Re: St. Lucie Plant Unit 2
Docket No. 50-389
Renewed Facility Operating License No. NPF-16

Supplemental Information Related to the Control Element Assembly Reactivity
Insertion Curve for the Extended Power Uprate License Amendment Request

**Supplemental Information Related to the
Control Element Assembly Reactivity Insertion Curve
for the Extended Power Uprate License Amendment Request**

**Figure 4.0-1:
Revised Normalized CEA Worth vs. Normalized Position
Following CEA Release from Reactor Trip**

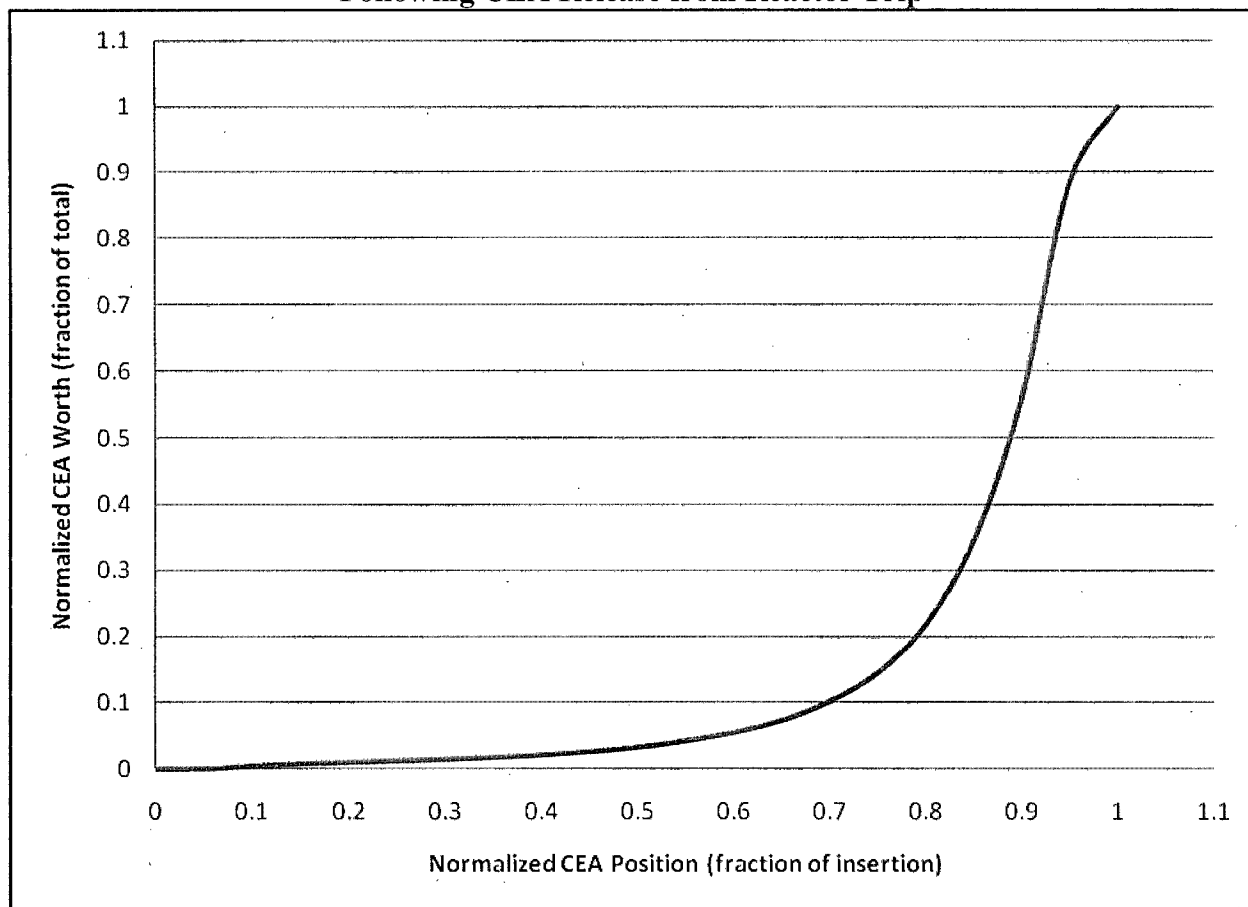
LAR Figure 2.8.5.0-4 presents the original normalized SCRAM curve. This figure is revised as shown in Figure 4.0-1.

This figure replaces LAR Figure 2.8.5.0-4.
